World Forum for Harmonization of Vehicle Regulations**Working Party on Lighting and Light-Signalling****Sixty-sixth session**

Collective amendments - Regulations Nos. 23 and 48**Proposal for [07] series of amendments to Regulation No. 48
(Installation of lighting and light-signalling devices)****Submitted by the Chair of the task force on courtesy lamp of the
Working Party on Lighting and Light-Signalling***

Model A

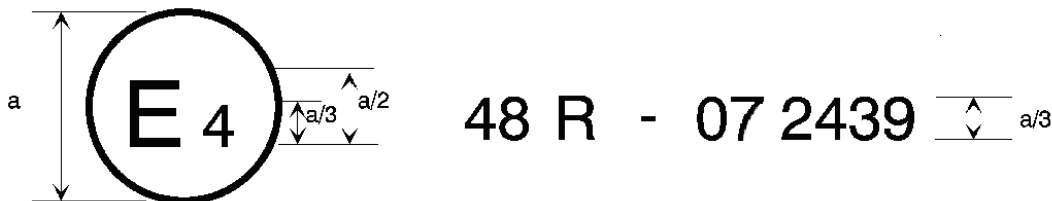
Annex 2, amend to read:

The above ... Regulation No. 48 as amended by the [07] series of amendments. The approval number indicates that the approval was granted in accordance with the requirements of Regulation No. 48 as amended by the [07] series of amendments.

Model B

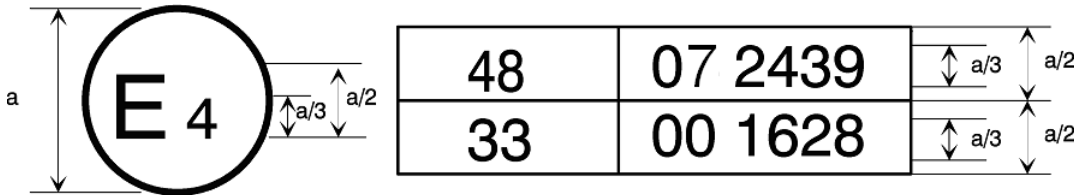
The above ... Regulation No. 48 as amended by the [07] series of amendments and Regulation No. 33.^{1/} The approval number indicates that, at the dates when the respective approvals were given, Regulation No. 48 was amended by the [07] series of amendments and Regulation No. 33 was still in its original form."
